The Village at Gibson Hill Subdivision Sterling, Connecticut

Environmental Review Team Report

Report #612

February 2007

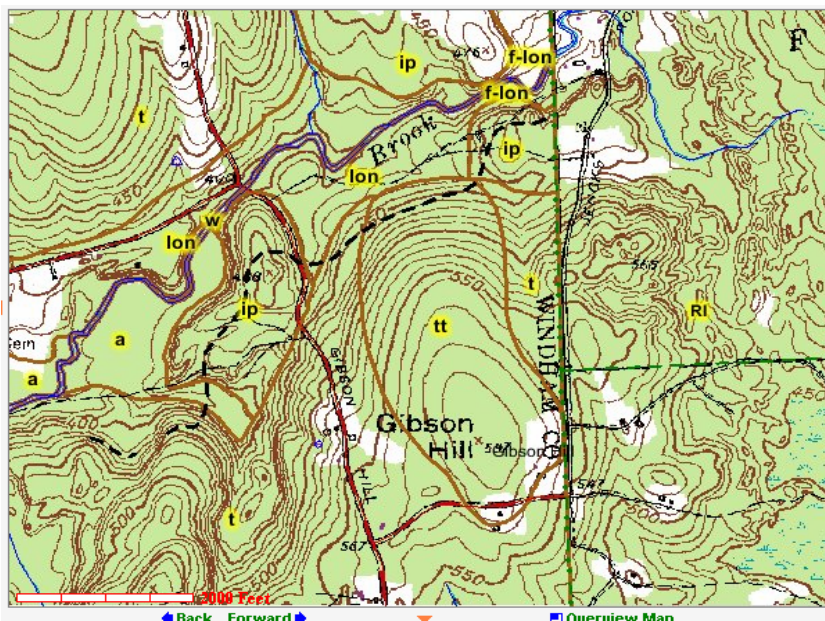
The proposed subdivision straddles the crest of Gibson Hill. Gibson Hill is a smoothly-contoured hill that is somewhat elongate in a NNW-SSE direction (Fig. 1). It has rather gentle slopes in all directions, particularly within the parcel under consideration. The hill has a relief of 200 +/- feet, but only 50 feet of relief are found on the parcel. Gibson Hill has the shape of a drumlin. It was formed beneath glacial-ice during the last Ice Age by both erosional and depositional processes.

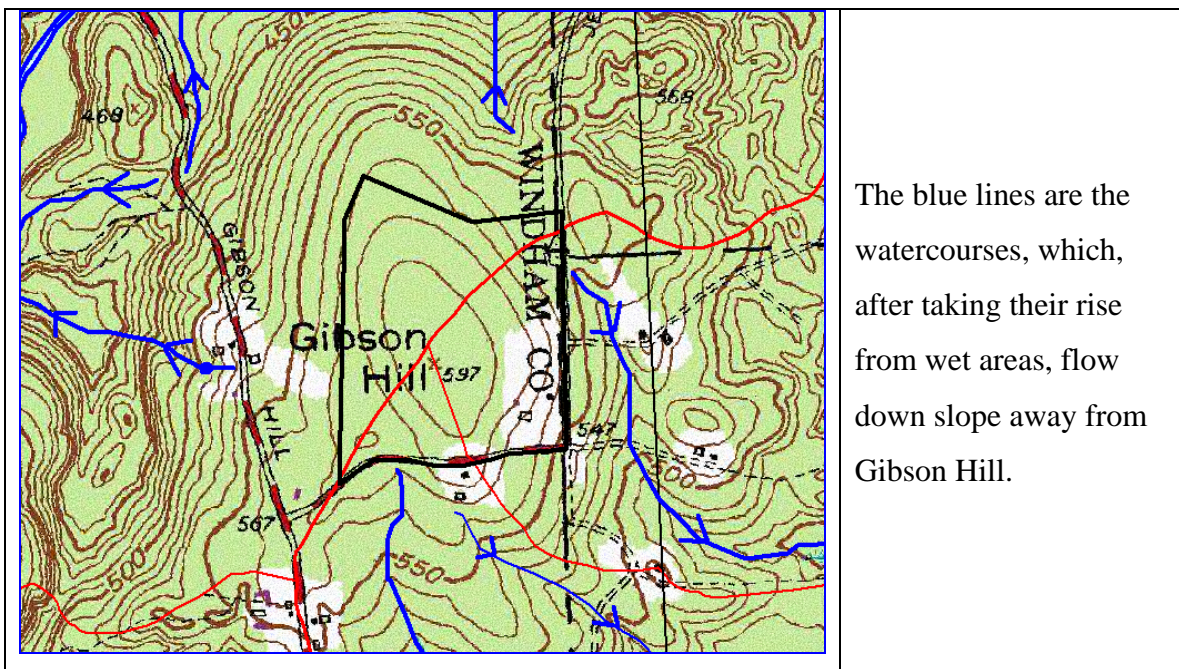
As seen in the image below, the high point on Gibson Hill is the top of the drainage divide for three separate watersheds (as delineated by the red lines). The northwest division makes up about 47 percent of the parcel and drains to the north, northwest and west. The triangle of land in the south central portion drains approximately 13 percent of the parcel. The balance, which drains to the east and southeast into Rhode Island, accounts for about 40 percent of the property.
